Reference: Beaver Valley Power Station, Unit No. 1
Docket No. 50-334
DCP 451

In our letter dated February 23, 1981, we committed to modifying the Main Feedwater Valve circuits to preclude opening of these valves upon reset of the Safety Injection Signal.

WESTINGHOUSE DRAWING NO. 1081H94

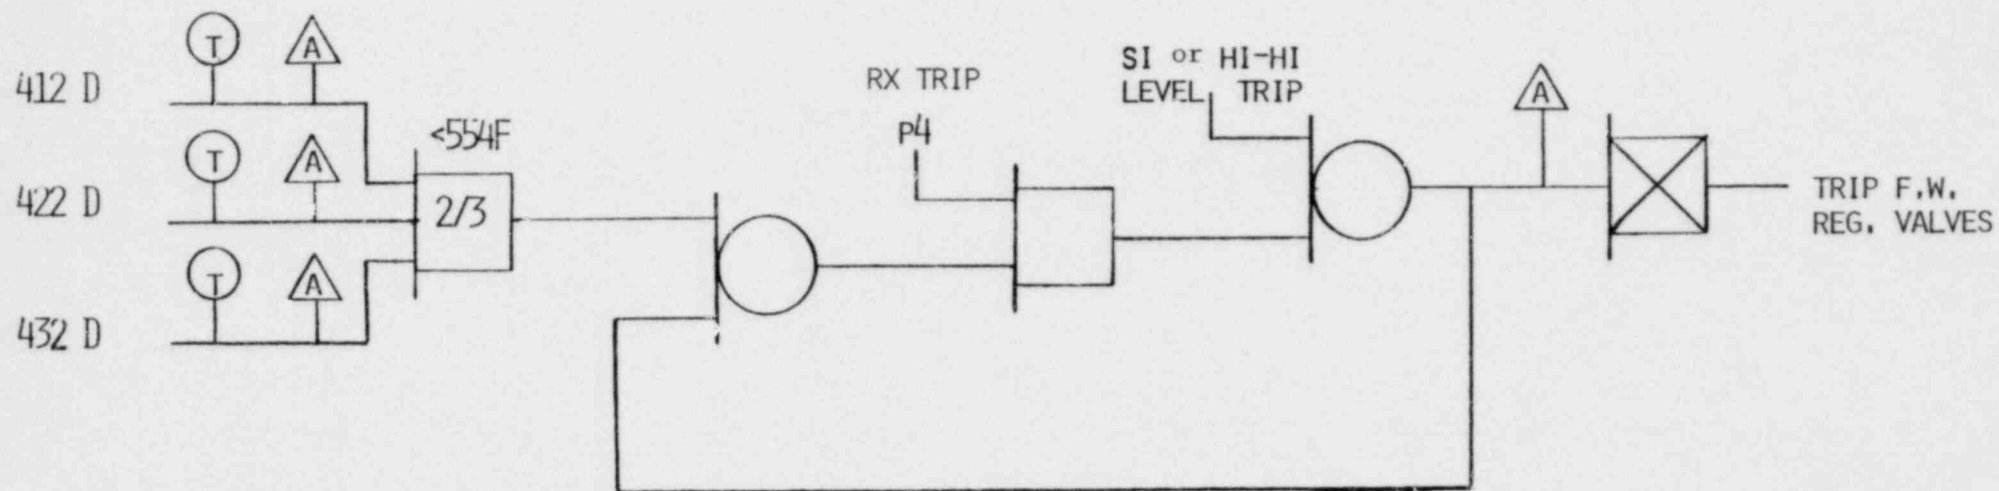
1. The Main Feedwater Valves will not automatically reposition upon reset of the SIS signal since a separate and redundant trip on the valves still exists. This signal is developed by a low Tave (less than 554F) coincident with a reactor trip signal (P4). Refer to the attached diagrams which depict this additional trip on the valves and to FSAR Figure 7.2-1 instrumentation and control system for additional information.

NOTE: The K601 relay contact is dropped out by an SIS signal and the K620 relay contact is operated by either a high-high steam generator level or the P4 and 554F logic.
